# GreenFuel Technologies: Case Study for Industrial Photosynthetic Capture

## *Follow-up Discussion*

## GreenFuel Response to Errors in Thermodynamic Analysis by Dr. Kassam Dimitrov (annotated references)

## Appendix 2 – Use of incorrect solar footprint for triangular reactor

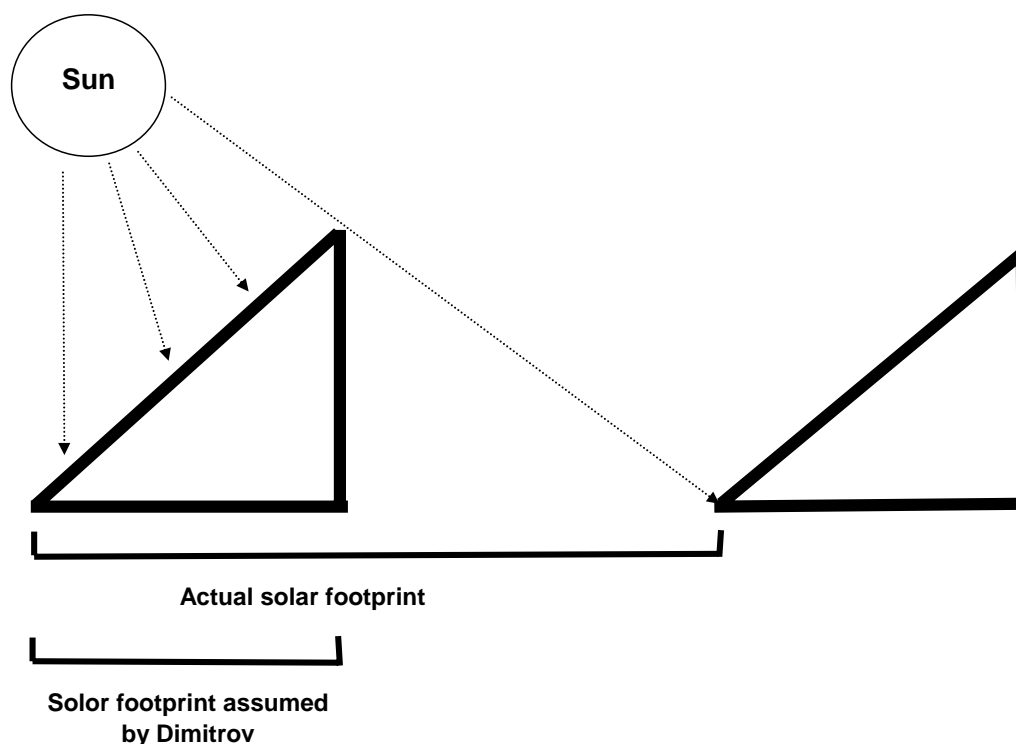
As Dr. Dimitrov shows, the total energy input to the system is the product of multiplying the total land area of the system by the energy flux. The first error is that Dr. Dimitrov uses the wrong value for the total land area of the system. He appears to have misinterpreted the area basis for Examples 2-5, in particular assuming that the total land area of the large-scale system is the same as the "footprint area" cited in the Examples. Closer reading of the application, particularly Figure 2 and Example 1, clearly shows that the "footprint area" is the area of the reactor system that is in direct contact with the ground. Due to the triangular shape of the bioreactors, they must be deployed over a larger area than their "footprint area", or they would shade each other and not be very effective. For the bioreactors in the Examples 2-5, one can see that the minimum spacing for capturing sunlight would result in a ratio of total land area to "footprint area" of at least 2:1. The diagram in Appendix 2 illustrates the error. Because Dr. Dimitrov incorrectly used the smaller "footprint area" in the calculation for total energy input, his results are low by at least a factor of 2. This is a common

6	GreenFuel Q of 44%	Dr. Dimitrov has simply misread the patent. The solar efficiency stated in GreenFuel's patent relates to the bioreactor (triangle) footprint area (20% !!!), which is clearly stated. The setup of the field layout is not described in the patent, which AT MINIMUM requires 50% spread (to prevent shading), and also depends on other geographical location and overall layout needs (service roads etc). This footprint based solar efficiency of 20% is in compliance with theoretical values of photosynthesis and published photobioreactor growth rate results. As a result of misunderstanding the areal basis of the solar efficiency numbers stated in the patent, Dimitrov's calculated Q is high by at least a factor of 2.
5	US PAR maps	Dr. Dimitrov uses incorrect PAR data. He cites satellite-based data as reported by the Department of Atmospheric and Oceanic Science at the University of Maryland, College Park (reference <a href="http://www.atmos.umd.edu/%7Eesrb/par/04status.htm">http://www.atmos.umd.edu/%7Eesrb/par/04status.htm</a> ). From this he concludes that the maximum PAR available in the Southwest is equivalent to an energy flux of 105 W/m <sup>2</sup> (averaged over a 24-hr day). In fact, the satellite data, which require corrections for several factors that influence PAR, underestimate the maximum PAR significantly. Kania, et al of the University of Arizona provide an analysis of PAR measurements in Tuscon over 13 years from AZMET (Arizona Metrological Network) (reference <a href="http://ag.arizona.edu/CEAC/research/archive/solar-radiation_kania.pdf">http://ag.arizona.edu/CEAC/research/archive/solar-radiation_kania.pdf</a> ). They show the maximum energy flux,

GreenFuel claims that in analysing Example 5 of GFT's Patent Application, I have used a wrong number in calculating the solar area of the installation. They also provide the following figure to demonstrate their point:

GreenFuel's claim is absolutely incorrect. *Example 5* describes an installation of **1.3 sq. km. or 321 acres**. My calculations generously assumed that the *entire* land area was used for solar capture: that is the solar aperture of the installation equalled its footprint. Contrary to what GreenFuel claims, no assumptions were made regarding the bioreactor geometry, as *Example 5* does not specify any particular geometry, and *Figure 4* in the patent application shows that the the photobioreactor can assume many different geometries. The point that the Case Study made was that an installation with a footprint of **1.3 sq.km (321 acres)** cannot possibly generate **342,000 barrels** of biodiesel – even assuming that the entire footprint is used for solar capture – as such annual yields would contradict the First Law of Thermodynamics. So in essence, what the figure above describes as “actual solar footprint” is exactly what has been used in my calculations.
